**STAFF REPORT**  
**COMMUNITY DEVELOPMENT DEPARTMENT**

HEARING DATE: March 3, 2022  
 TO: Planning & Zoning Commission  
 FROM: Joseph Dodson, Associate Planner  
 208-884-5533  
 SUBJECT: H-2021-0096  
 Aviation Subdivision

Preliminary Plat for 48 building lots (6 single family attached lots, 31 townhome lots, 2 detached single-family, and 9 multi-family lots), 8 common lots, and 1 other lot and a Conditional Use Permit for 36 multi-family units on 9 lots on 9.8 acres in the R-15 zoning district.

# C. Landscape Plan (date: 8/03/2020)

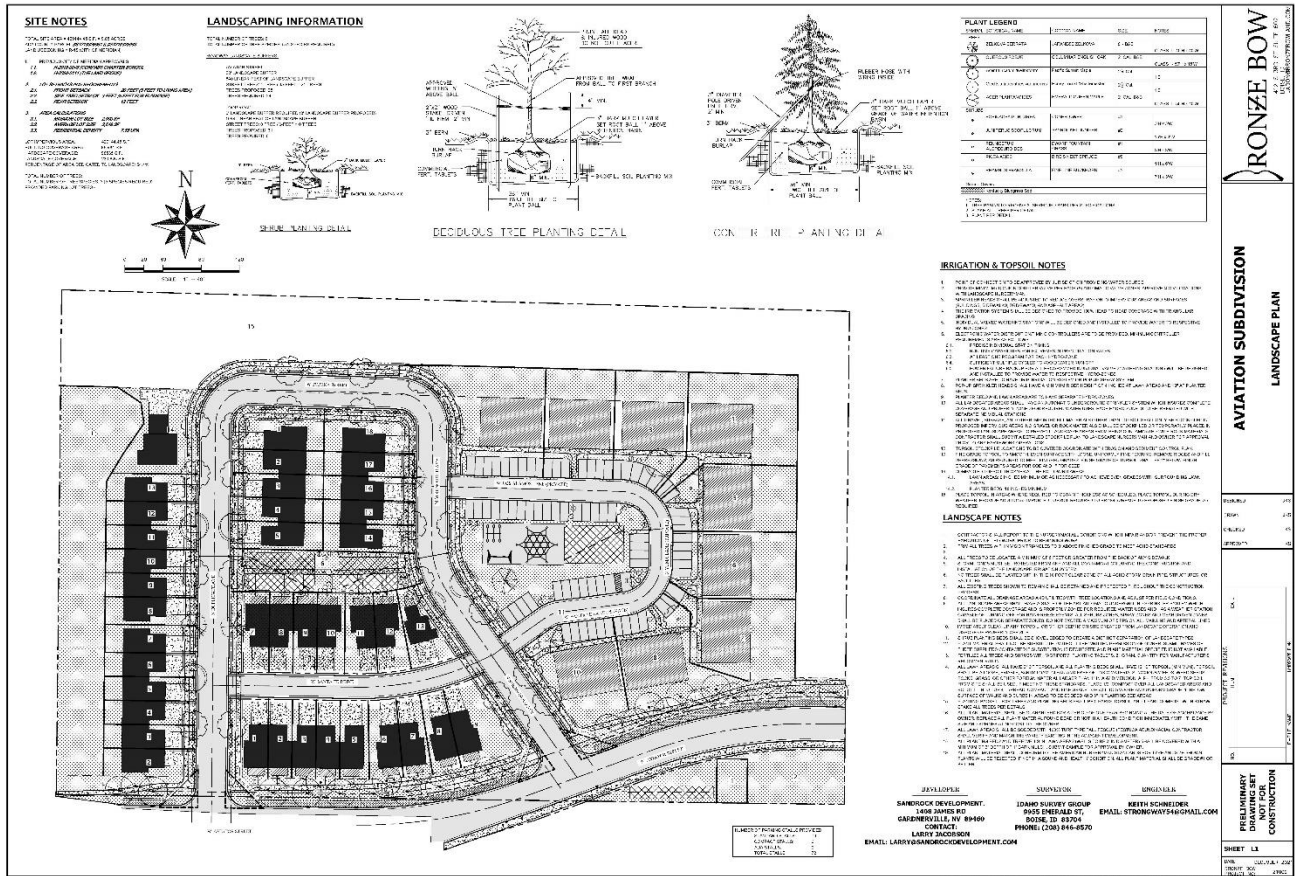
A 20-foot wide street buffer is required along the extension of W. Aviator Street (measured from back of curb), landscaped per the standards in UDC Table 11-3B-7C. A 20-foot wide common lot is shown on the north side of Aviator on the submitted plat in accord with UDC standards. The common lot along the south side of Aviator that is on the property is wider than 20 feet but is shown with an attached sidewalk instead of a detached sidewalk. Further, there are no trees shown on the south side of Aviator as required by the UDC. Per the plat condition noted, the Applicant should revise the landscape plan to show the required buffer trees on the south side of the Aviator extension.

According to the submitted landscape plan, some trees are included in the common open space areas due to the parkway trees along the local street. Staff is recommending an additional tree be placed in the center of the open space lot within the single-family portion of the project (Lot 6, Block 2) to add an area of shade in the center of this open space lot.

Staff has excluded the open space area that has the Purdam Drain irrigation easement within this calculation as the irrigation district does not generally allow trees within their easement. **However, Staff recommends the Applicant coordinate with the irrigation district to see if some trees could be placed strategically in order to provide some areas of shade in this area closest to the buildings, so this area could count towards qualified open space.**

- e. Add a plat note stating who is responsible for the maintenance of the Compass Charter School drain field located on Lot 1, Block 6.
13. The submitted landscape plan, dated December 2021, shall be revised prior to the first final plat submittal, unless otherwise noted:

- a. Work with Nampa Meridian Irrigation District (NMID) to install a 5-foot wide pathway along the south and west side of the relocated Purdam Gulch Drain to further comply with open space and amenity standards; new pathway should provide a pathway stub to the east boundary and connect to the detached sidewalk along W. Aviator and the detached sidewalk along the internal local street near the north end of the site to create a looped walking path.

- b. Add data to the landscape plans showing compliance with UDC 11-3B-7C for the proposed parkways.
  - c. Show the required street buffer trees within the required 20-foot buffer on the south side of the W. Aviator extension.

- d. Add an additional tree in the center of the open space lot within the single-family portion of the project (Lot 6, Block 2) to add an area of shade in the center of this open space lot.

- e. Add a picnic area or other amenity worth at least one (1) amenity point in the single-family portion of the project (Lot 6, Block 2) to comply with UDC 11-3G-3 amenity standards.

- f. Provide verification from NMID the common lot containing the piped and rerouted Purdam Drain can be vegetated with grasses; if it is not allowed, the Applicant should obtain a letter to that effect from NMID (should this area not be allowed to contain grasses, it may not qualify towards the open space calculation).

# D. Open Space Exhibit

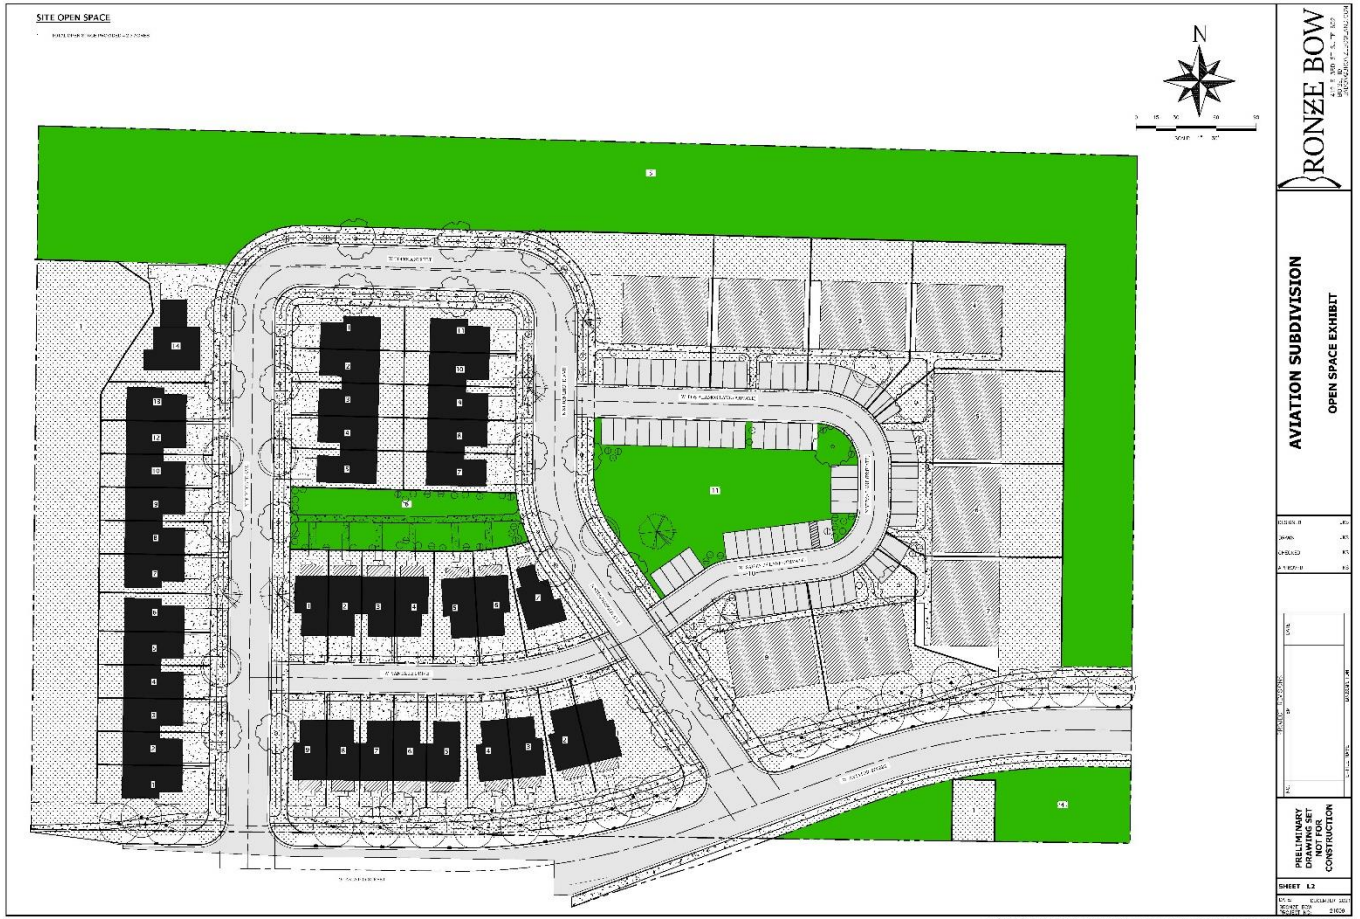
*According to the submitted plans, the Applicant is proposing approximately 155,200 square feet (3.56 acres) of common open space within common lots (not all of this is qualified). However, this area is still not fully accurate as some of the Purdam Drain easement area is located on buildable lots and the open space calculation does not include the parkways that are qualifying open space. This shows the actual open space area is even greater. If only the two central open space lots, the Purdam Drain common lot (excluding the area on the buildable lots), and the common lot in the southeast corner of the site is taken into account, the amount of qualified open space is approximately 2.5 acres. Therefore, the proposed open space vastly exceeds the minimum amount required by code for both the single-family and the multi-family portions of the project.*

Based on the size of the single-family area of the plat, one (1) point of site amenity is required to meet UDC 11-3G-3 standards. According to the submitted plans, the Applicant has not provided an amenity to satisfy these requirements. The Applicant should revise the landscape plans to include an amenity worth at least one amenity point within the single-family area of the project (i.e. a picnic area). The amenity analysis for the multi-family portion of the development is provided below.

E. Conceptual Building Elevations (NOT APPROVED)

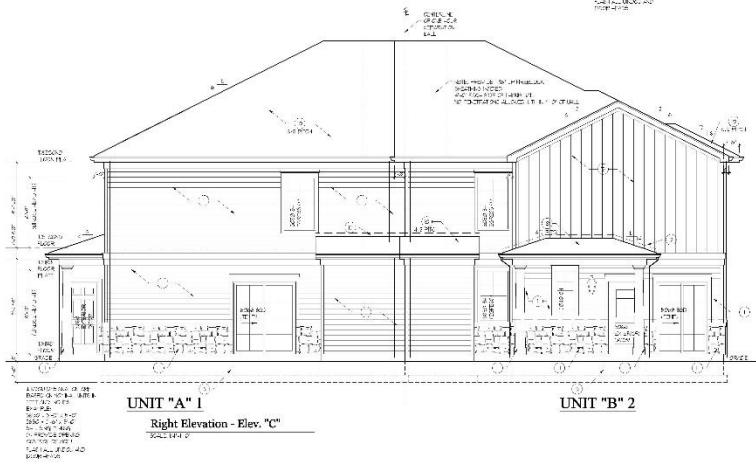
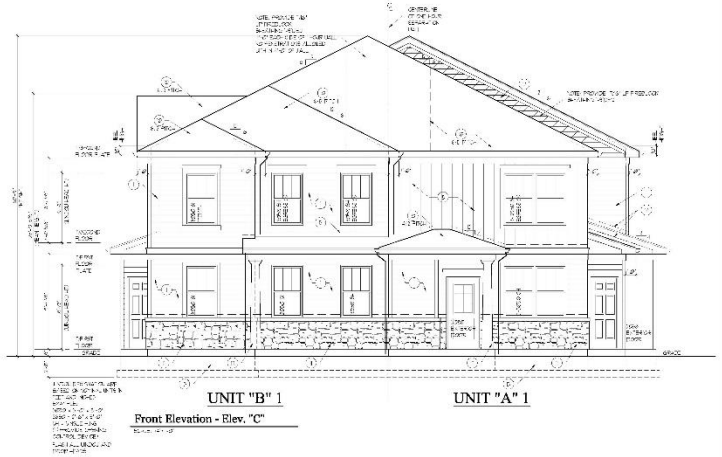
*The proposed alley-loaded units (taking access from a public, minor urban-local street) have porches along the street frontage or face green space entirely (i.e. Lots 7-13, Block 2); all of the remaining front-loaded townhomes have a garage dominated façade facing the internal local street. As discussed above, the front-loaded garages are not located 20’ behind the primary façade of the structure and do not comply with the approved conceptual elevations and floor plans in the DA. However, with the noted site constraints and the current lot configuration, full compliance with the garage setback requirement may not be possible – the lots would need to be widened and the number of units would need to be reduced to comply. The Applicant is required to increase the number of units to comply with the minimum density requirements in the DA and the MHDR designation so losing additional lots is not viable under the terms of the approved DA unless the DA is amended. Therefore, Staff recommends the Applicant explore alternate design options to be more consistent with this requirement while maintaining a gross density of at least 8 units per acre; an alternate floor plan and revised elevations in compliance with the recorded DA should be submitted in accord with this provision prior to the City Council hearing.*

Conceptual building elevations were submitted for the proposed 2-story townhome structures and the multi-family 4-plex buildings as shown in Section VII.F; conceptual elevations for the single-family attached units and the two detached units were not submitted. See additional analysis in the Comprehensive Plan section above (Section V.A). The conceptual building elevations for the townhomes do not list specific materials but appear to show a combination of stone and stucco field materials. The conceptual elevations for the 4-plex units depict varying designs of board & batten siding with stone accents. As noted above in Section V.A, Staff is recommending changes to the front-loaded townhome units in order to better comply with the Ten Mile Plan. In addition to those recommendations, Staff is also recommending the Applicant provide modulation in the building placement for the townhome buildings, especially those along the west boundary, to ensure the building wall-plane is not a monotonous wall of garages.

14. The submitted conceptual elevations for the townhome and single-family attached units shall be revised as follows at least ten (10) days prior to the City Council hearing:

- a. Applicant shall comply with the design guidelines within the TMISAP.
  - b. Explore alternate design options to be more consistent with the street oriented design standards within the Ten Mile Plan while maintaining a gross density of at least 8 units per acre; an alternate floor plan and revised elevations should be submitted in accord with this provision.

- c. Revise the elevations to correspond the street level and upper level architectural detailing to unify the design.
  - d. Provide additional modulation in wall plan and roof height variation.
